ADDENDUM NO. 4 TO PROJECT NO. 44813

**CONSTRUCTION WORK
REPLACE WINDOWS
HENDERSON-SMITH STATE OFFICE
BUILDING
107 BROADWAY
HORNELL, NY**

December 8, 2015

PROJECT NUMBER:	44813	-	C
DESIGNED BY:	TAV		
DRAWN BY:	TAV		
FIELD CHECK:	TAV		
APPROVED:	MMR		
SHEET TITLE:	WINDOW DETAILS		
DRAWING NUMBER:	A-502		
SHEET	12	of	12

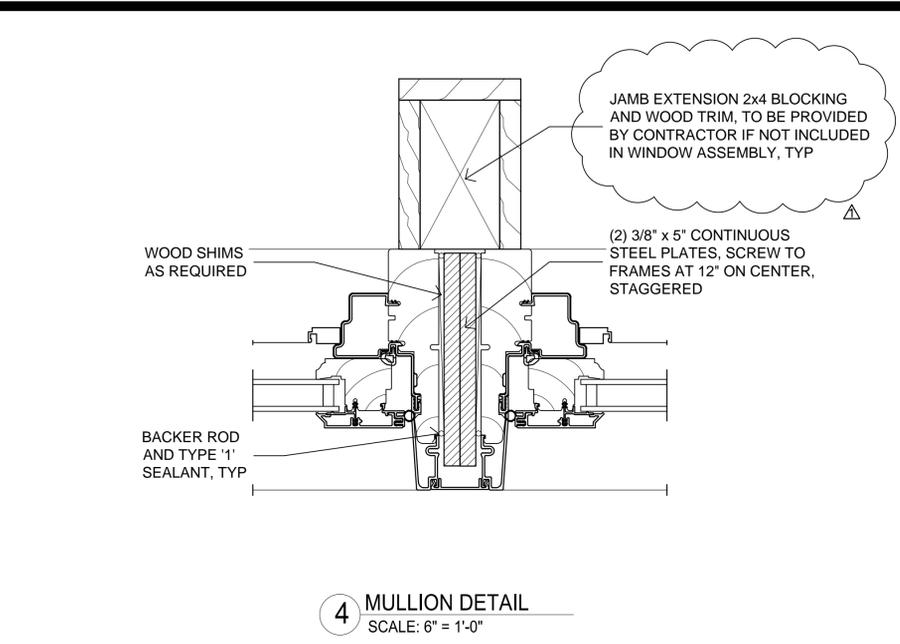
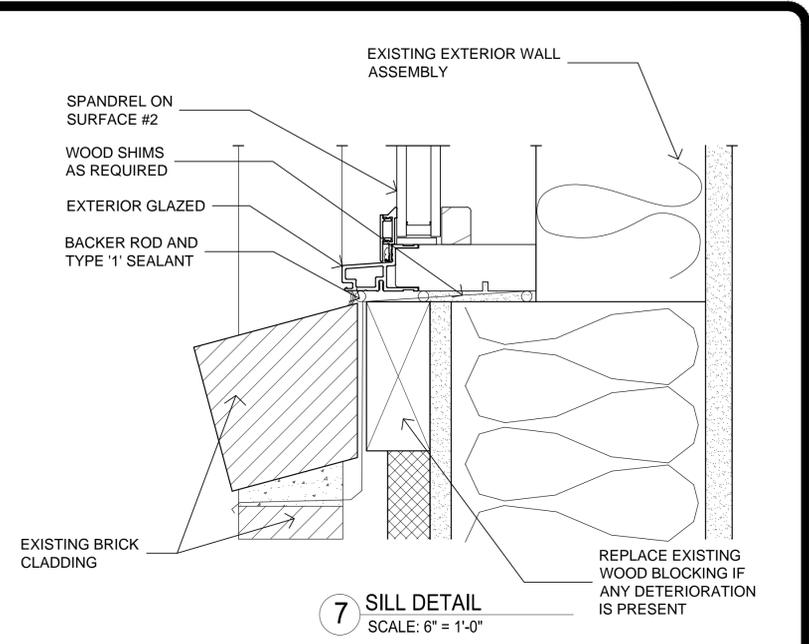
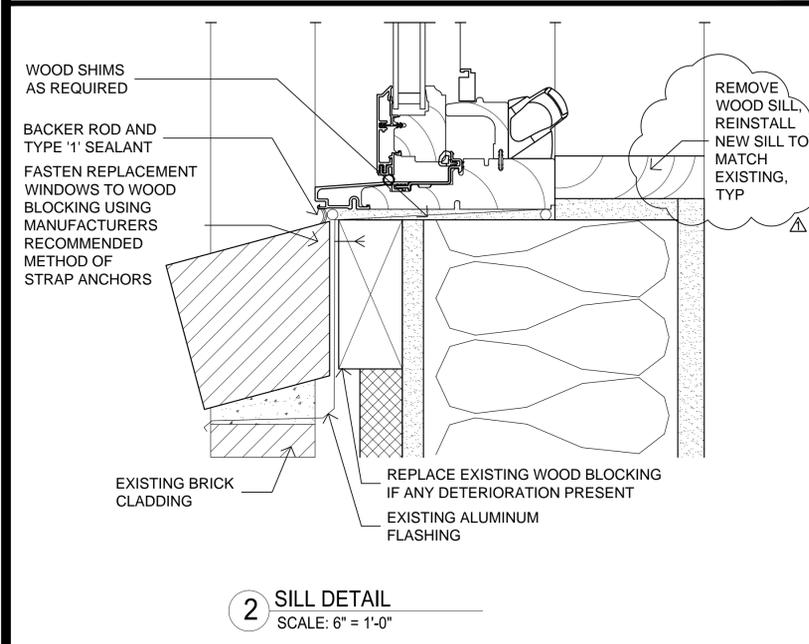
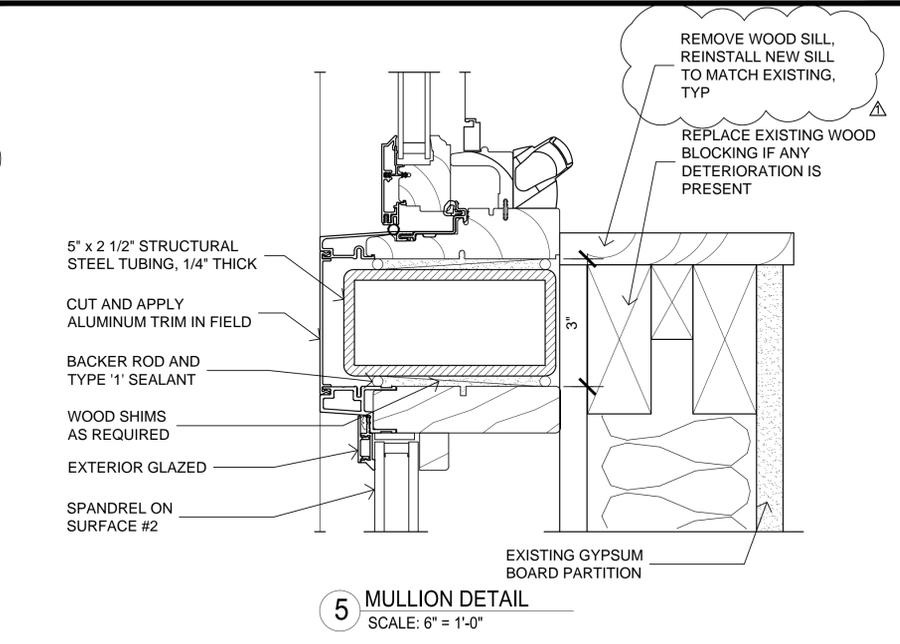
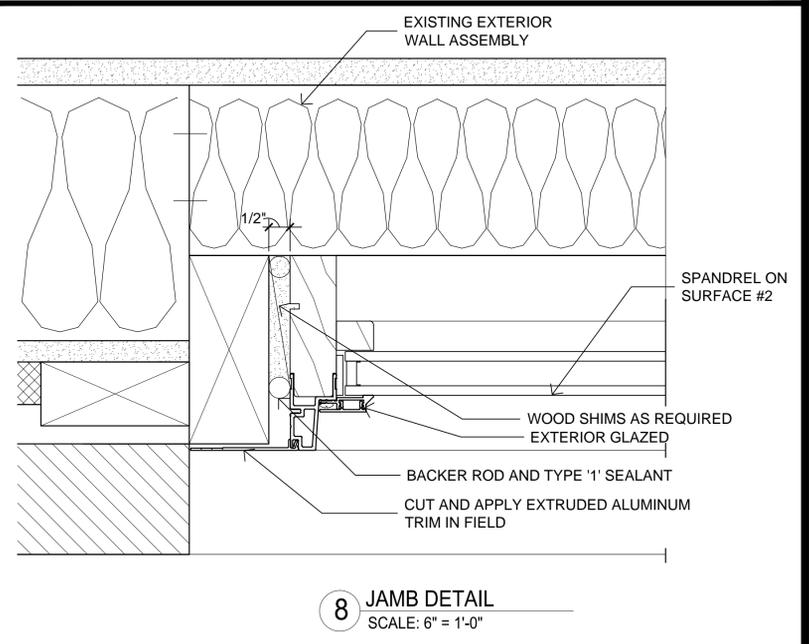
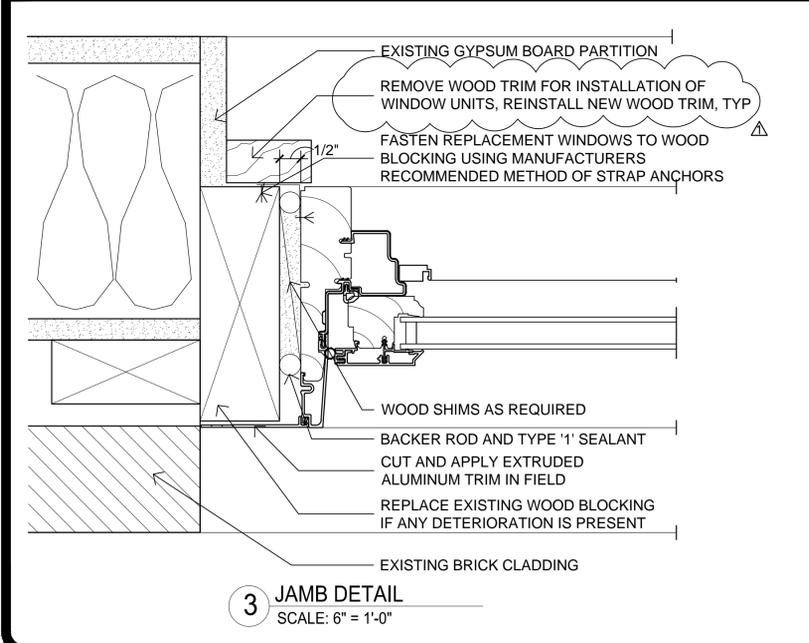
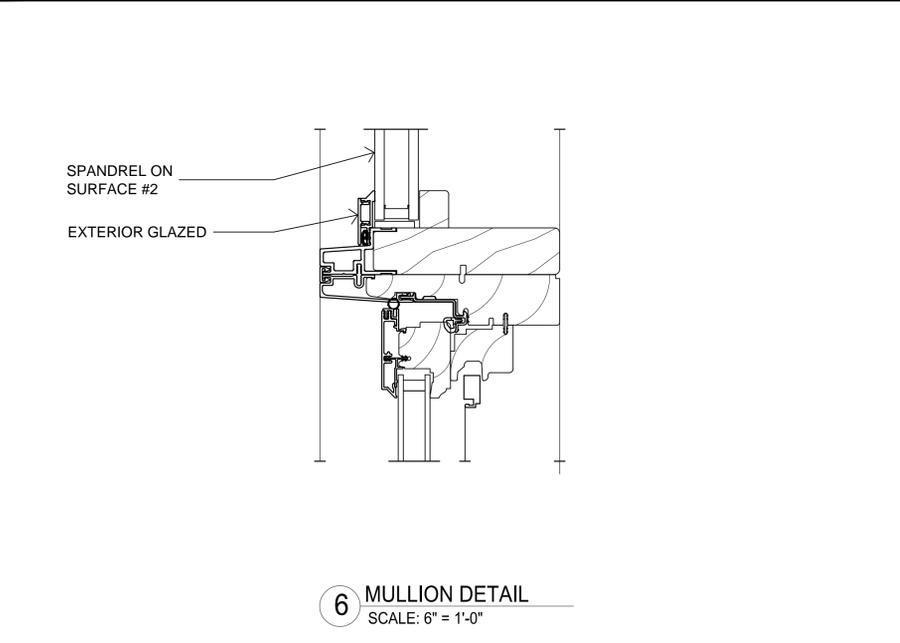
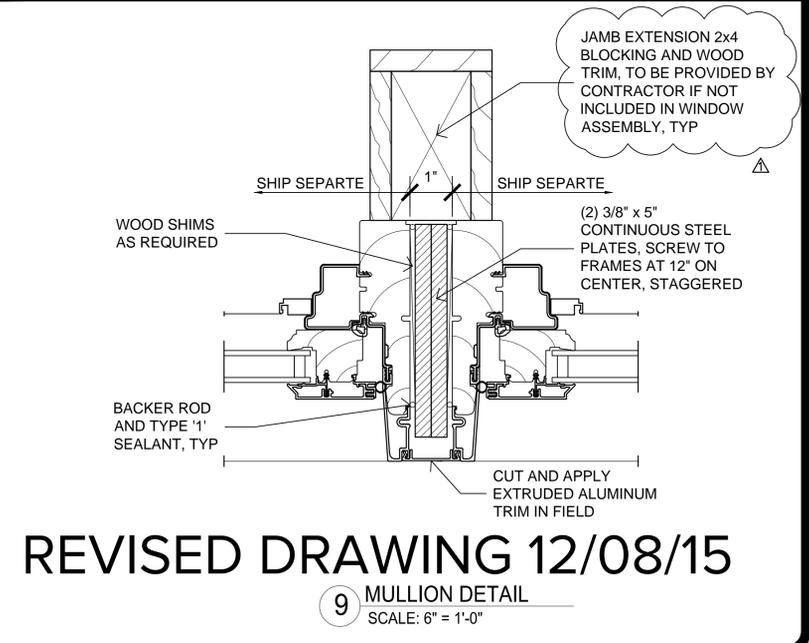
2. Drawing Nos. A-101, A-102, and A-103, FLOOR PLAN KEYNOTES, Note 2: Delete this Note in its entirety and replace with the following:
"2. REMOVE AND DISPOSE OF EXISTING WINDOW UNITS. REMOVE WINDOW TRIM FROM INTERIOR. REMOVE WINDOWS FROM EXTERIOR OF BUILDING. REMOVE ASSOCIATED BLOCKING NO LONGER CAPABLE OF SECURING FASTENERS."
3. Drawing Nos. A-201, A-202, and A-203, FLOOR PLAN KEYNOTES, Note 2: Delete this Note in its entirety and replace with the following:
"2. INSTALL NEW INTERIOR WOOD TRIM ALONG PERIMETER OF WINDOW UNITS TO MATCH EXISTING. DIRECTOR'S REPRESENTATIVE TO APPROVE MATCHING TRIM WOOD AND STAIN SELECTION."
4. Revised Drawings:
 - a. Drawing No. A-502, noted "REVISED DRAWING 12/08/2015" accompanies this Addendum and supersedes the same numbered originally issued drawing.
